Your ref:  
Our ref: LTR-RAC-20-83

Subject: Response to SCDHEC Letter dated October 14, 2020  
Phase II Work Plan *Addendum*

## **Attachment A: Westinghouse responses to the SCDHEC letter dated October 14, 2020**

- **B-B’ Cross Section Used in the Conceptual Site Model (CSM)**

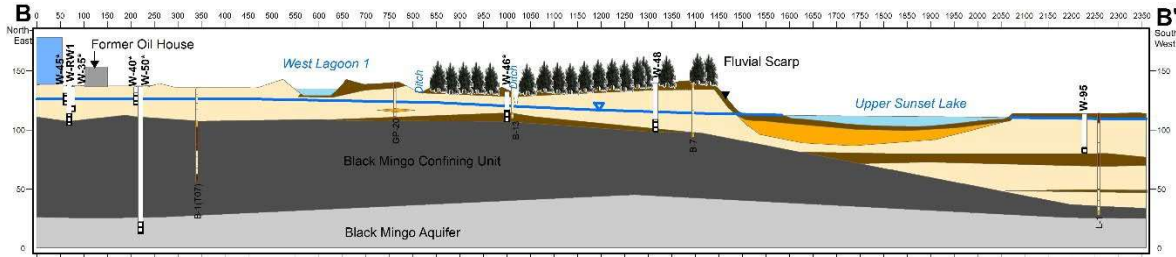
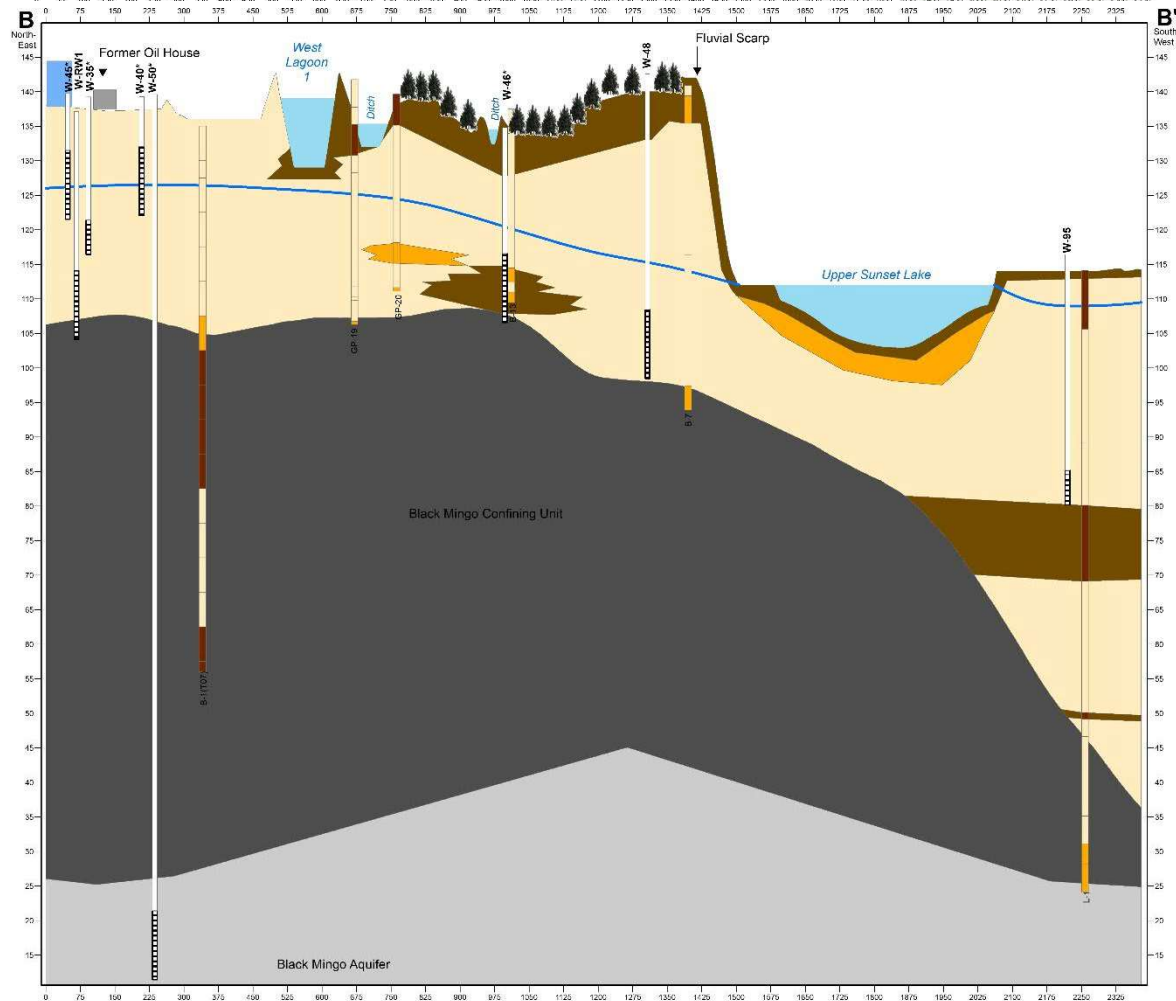
A slide deck of the CSM (Revision 1a) was submitted to DHEC in July 2020 as part of the Final RI Interim Data Summary Report. Since the submission, it was noted that when the 15X vertical exaggeration was added, not all of the subsurface units increased in the corresponding exaggeration thickness. The following subsurface layers were revised to correspond to the 15X vertical exaggeration: the silt and clay layer beneath Upper Sunset Lake, the surficial silt layer south of Upper Sunset Lake, and the Black Mingo Confining Unit slope to match with the its depth below ground surface in boring L-1.

Attached is a revised cross section B-B’ of Rev. 1a of the Conceptual Site Model.
